R4B Supplementary Design Statement for S4.55 MOD

Renzo Piano Building Workshop | One Sydney Harbour | Design Report | June 2021

R4B SUPPLEMENTARY DESIGN STATEMENT FOR S4.55 MODIFICATION APPLICATION  
June 2021

Diagram – Wind baffles at southern end of covered roof

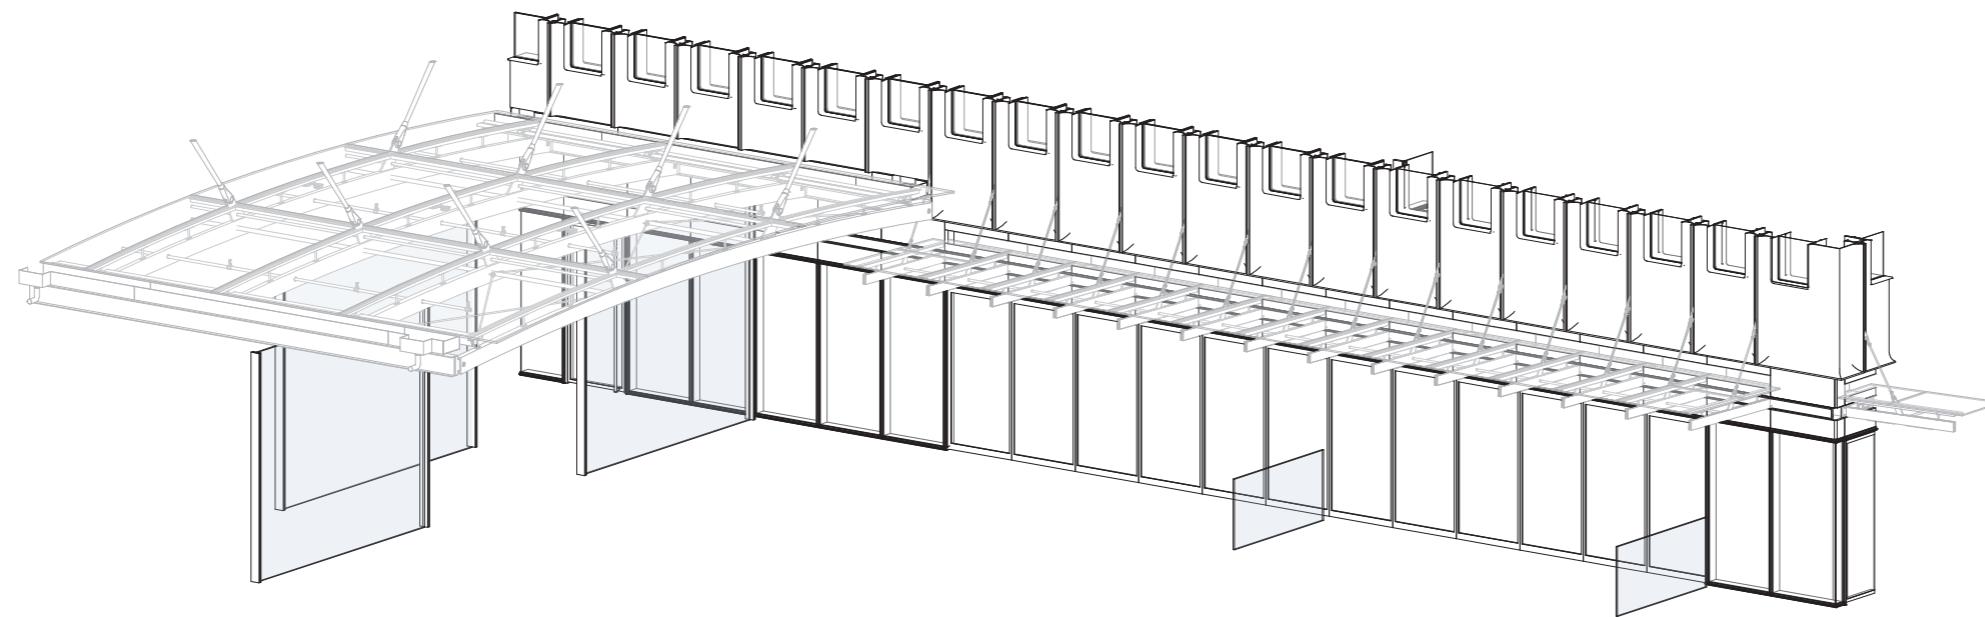
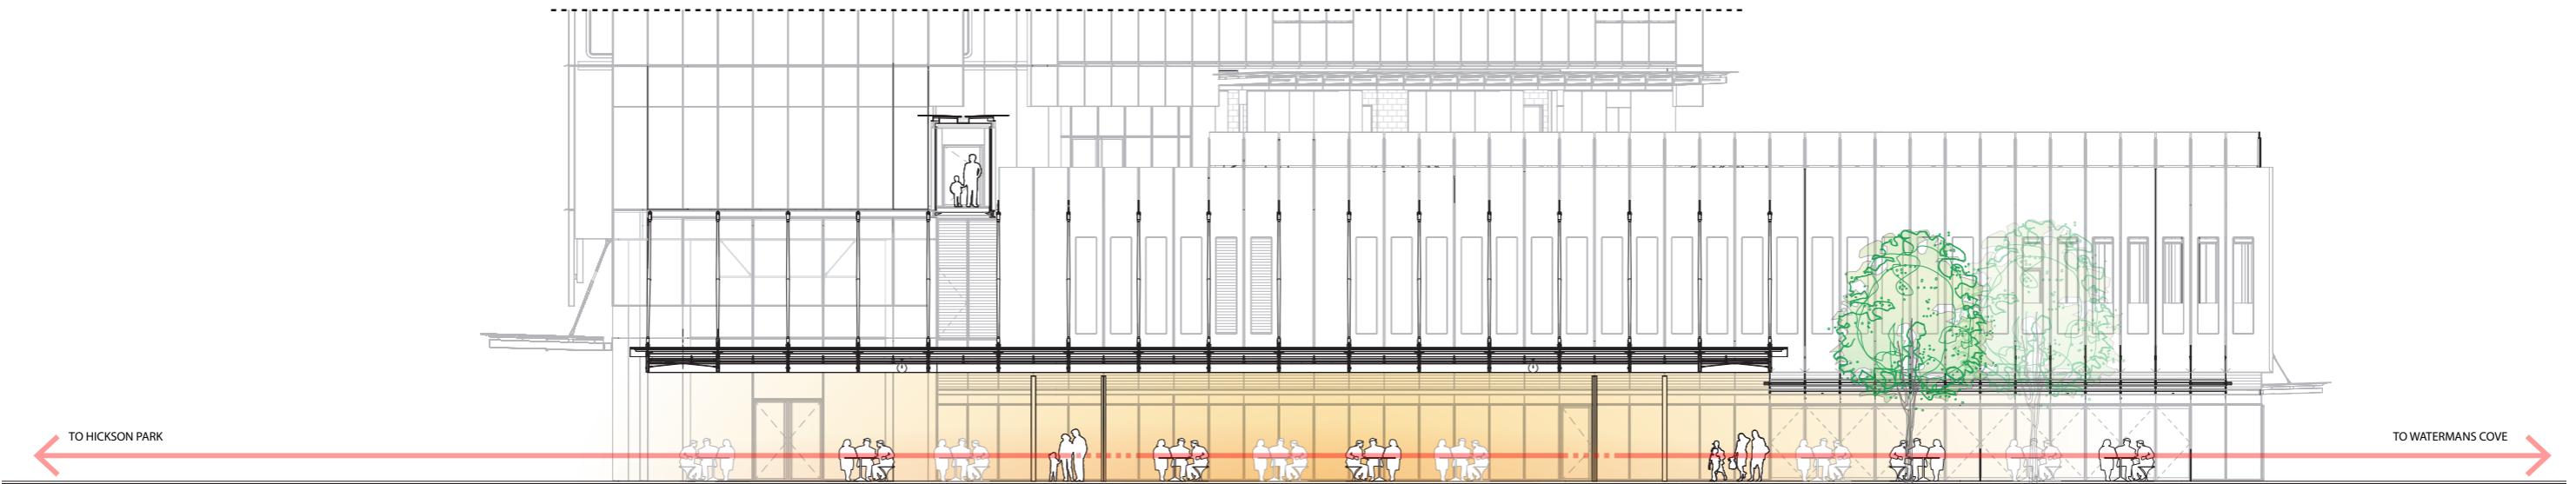
The modification application seeks to transfer the delivery of the strada ground plane and areas from the R4A development consent (SSD 6964) to the R4B development consent. The R4B development consent includes the roof of the strada, accordingly it is considered appropriate to also include the associated ground plane under one planning approval. Under the development consent for R4A (SSD 6964) the wind mitigation measures for the strada space under Condition B5 were approved via a Secretary Approval. This includes the addition of glass wind baffles within the strada. For completeness, these wind mitigation measures are therefore part of the modification, to provide their delivery through Building R4B

Proposed Entrance - Plan

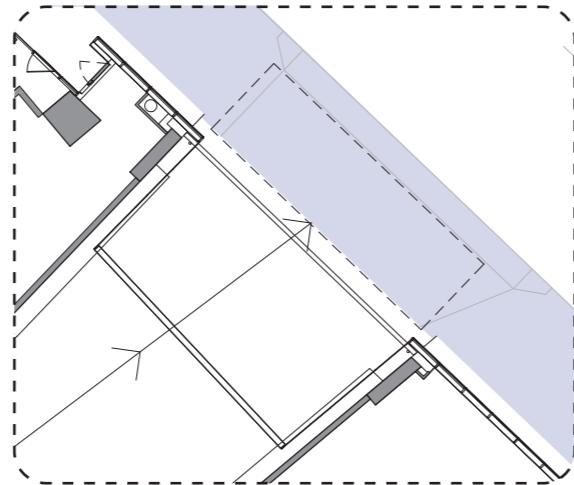
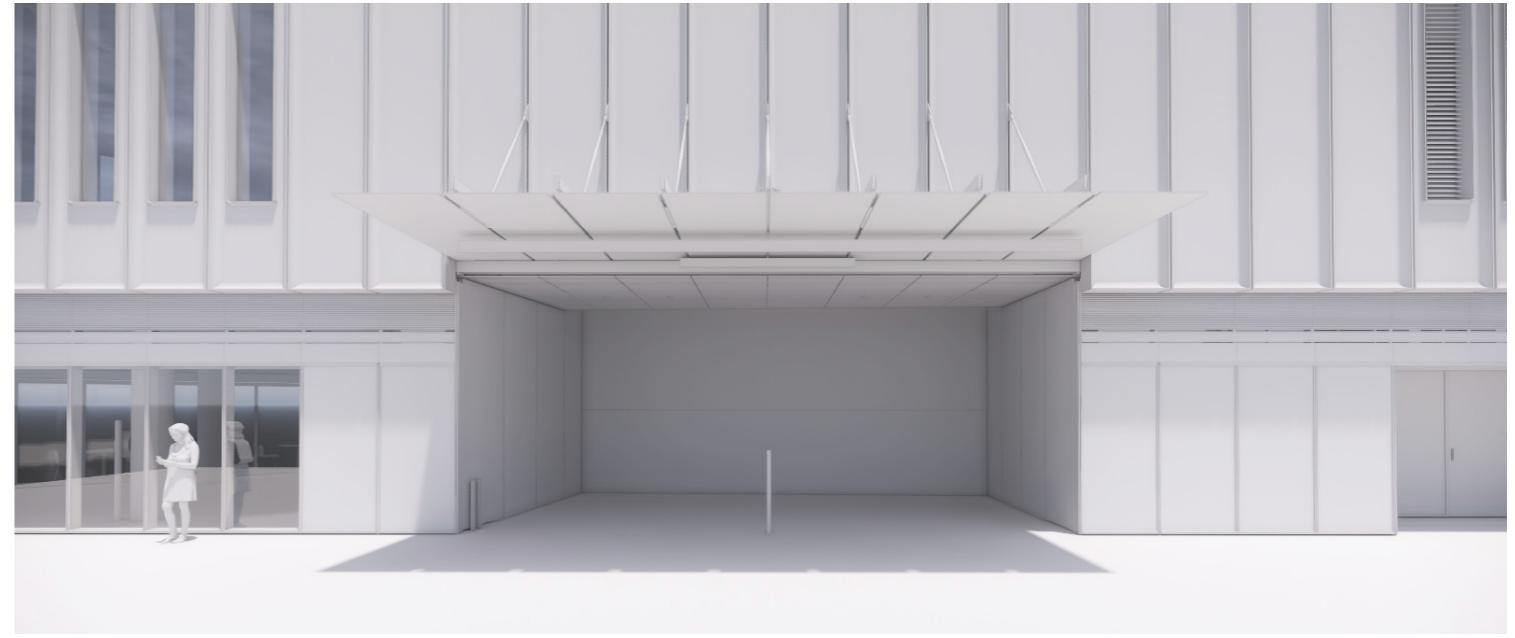
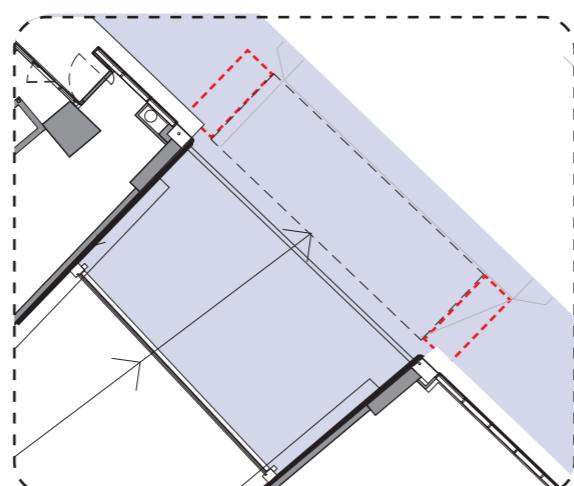
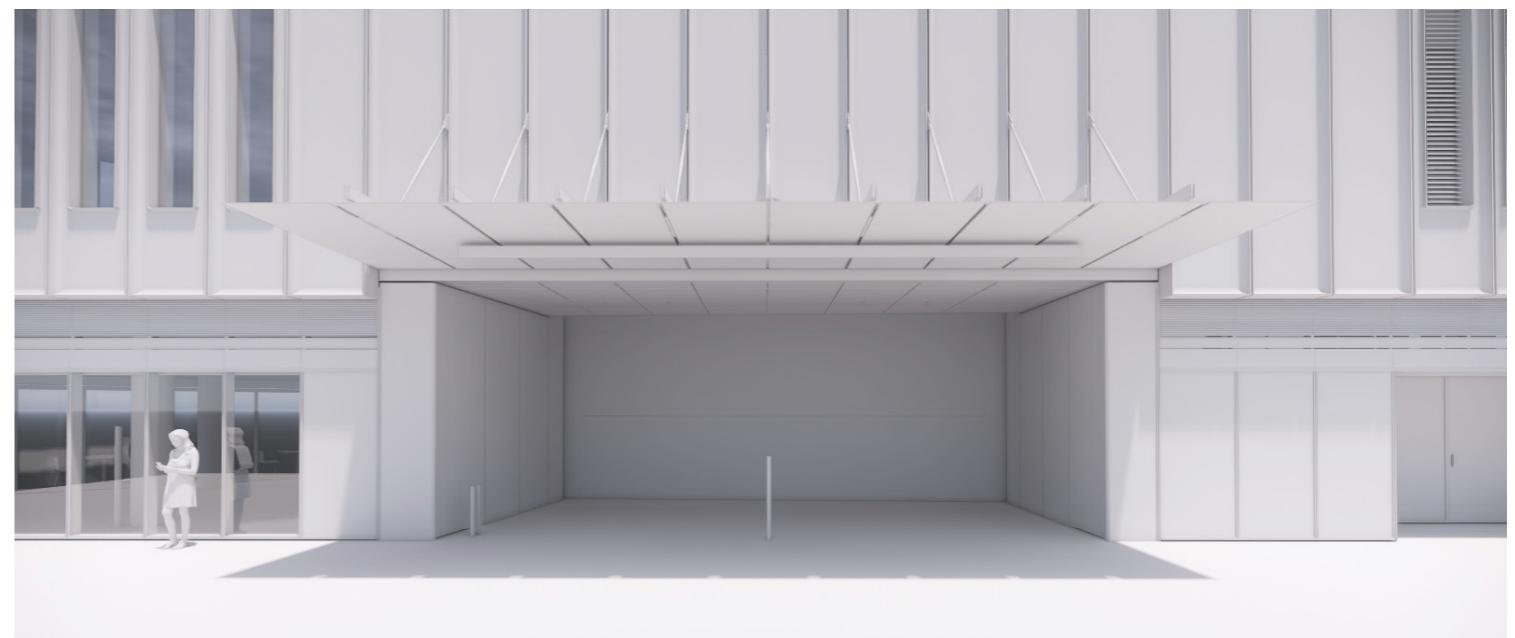
It has been identified that there is a potential risk of impacts to the cladding on either side of the carpark entrance ramp and potentially to other vehicles approaching in the opposite direction. To mitigate this risk, the opening was widened slightly within the bounds of the approved structure. This had the effect of increasing the width of the carpark. As such, the awning was also increased in width to ensure a coordinated design outcome.

A further amendment in this area relates to the extent of paving. In the approved design, the City of Sydney Council stone would be restricted to the pedestrian footpath. On the proposed scheme, the stone is extended until the garage door, allowing a more uniform and refined design.

Added awning modules

City of Sydney stone extension

Proposed South Facade Skirt and Portal

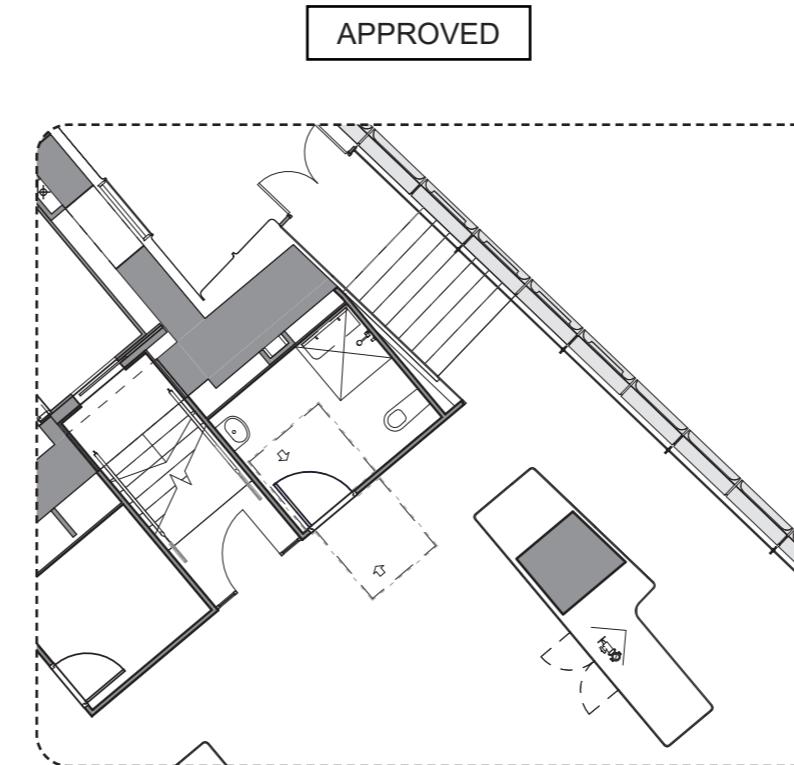
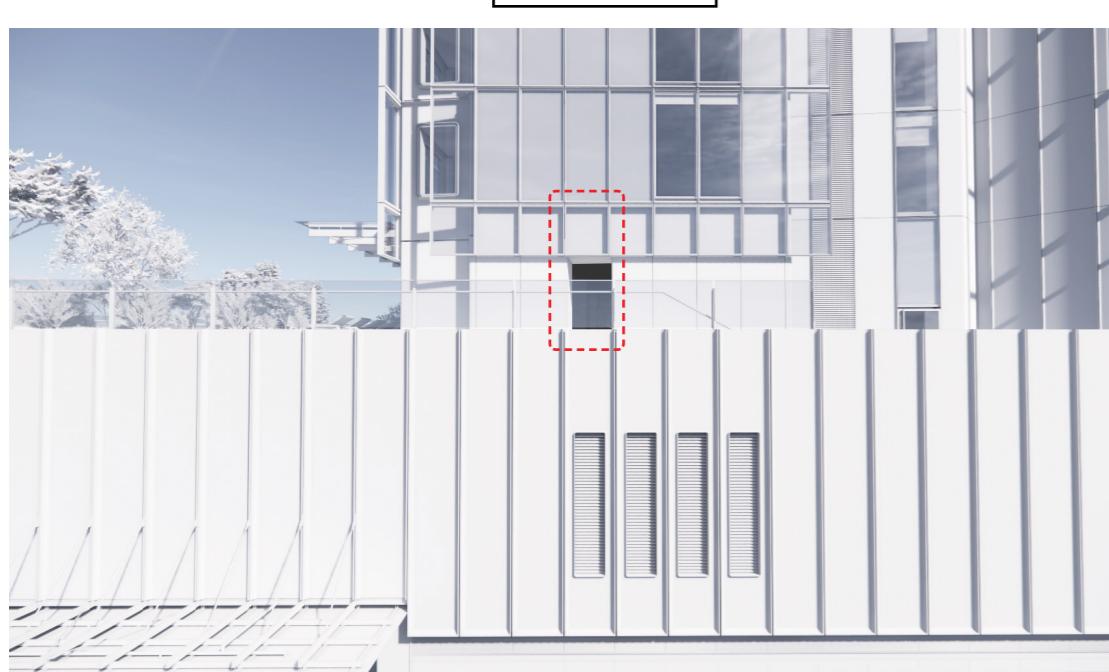
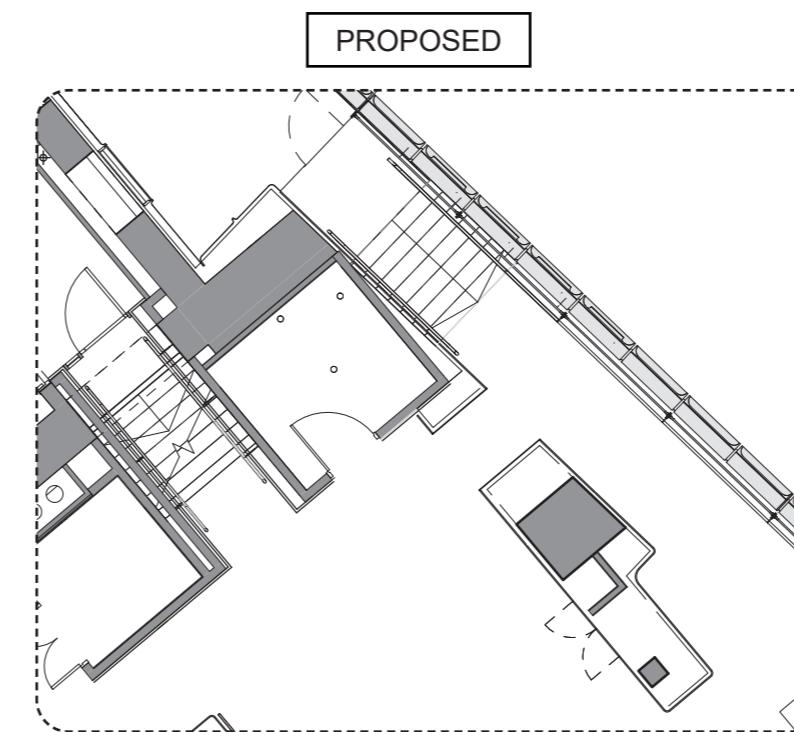
Through the design development of the 'skirt' of the south tower facade which faces Watermans Quay it was identified that there was an open spandrel 'shadow box' that would present ongoing challenges to access and maintain. Through this planning amendment it is proposed to simplify the portal below the skirt in order to close this shadow box and thus create a more robust design.
